THE H2 TEESSIDE PROJECT

#### WRITTEN SUBMISSION AT DEADLINE 5 ON BEHALF OF NATIONAL GRID ELECTRICITY TRANSMISSION PLC

RESPONSE TO THE EXAMINING AUTHORITY'S SECOND WRITTEN QUESTIONS & REQUESTS FOR INFORMATION [PD-015]

# Engineering Constraints Report

Figure 4 Option 2 substation to the west of the site

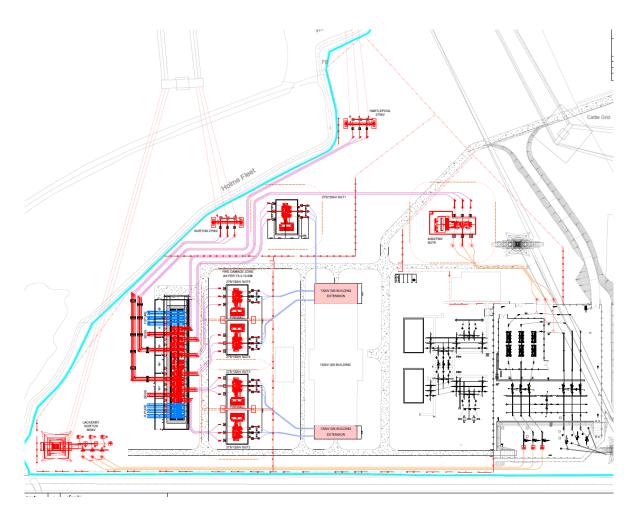
- 3.4.5 The Lackenby Norton 400kV OHL is required to be rerouted from it's existing position to allow for the SGT's to be sited linearly as shown in Figure 4. This requires the existing tower 'YYJ037' to be removed and replaced with a tower and CSE which would be installed in the southwest corner of the site. The 400kV circuit would then be cabled along the southern border of the site into the existing 400kV substation. The tower and CSE will be accessed through the new substation.

- 4.5.2 There are two interactions between the AGI and substation proposals shown in Figure 8 which would restrict the installation of those assets:
  - The new tower and CSE required would be in direct conflict with the positioning of the AGI. The position and orientation of the tower is such to ensure electrical clearances from the proposed substation development and would be required to be situation there to ensure the substation could be built and maintained safely.
  - The AGI and substation proposals would directly abut one another making construction of the substation challenging. Furthermore, customer cable routes into the most southerly bays would not be achievable effectively sterilising those bays.

- 4.5.3 There are several interactions between the access and substation proposals shown in Figure 8 which would restrict the installation of several NGET assets:

- The northwestern edge of the substation compound would be required to be installed over the access road to allow for access into the GIS building an provide hardstanding for large deliveries.

Figure 5 Overview of H2 Teesside Limited's proposal

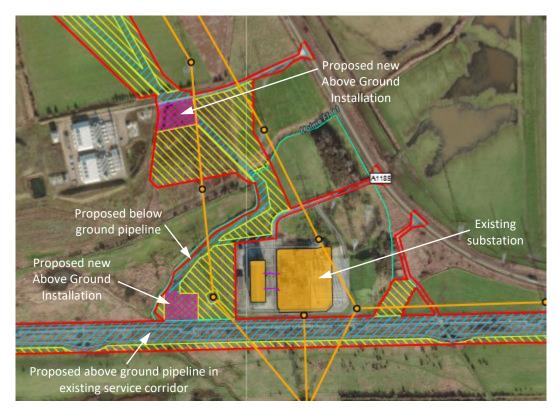
- 4.1.1 The substation options considered in the previous section highlight the difficulty in developing a substation if any of NGET's land is acquired or used for other purposes.
- 4.1.2 The layout drawings for each of the substation options presented have been overlaid onto H2 Teesside Limited's proposal to clearly show the incompatibilities.
- 4.1.3 The following paragraphs outline the anticipated conflicts with relevant elements of the H2 Teesside proposal (including Work Nos. 6A.1 and 6B.1, 9 and 10A.1).

Figure 12 Substation site drainage details

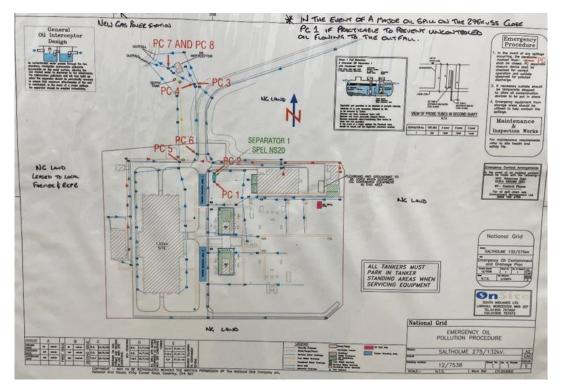
**7.8.2** Site drainage at Saltholme substation is very complex (Reference Figure 12 below). There is potential interaction with the drainage system with the proposed hydrogen pipeline route to the north west.
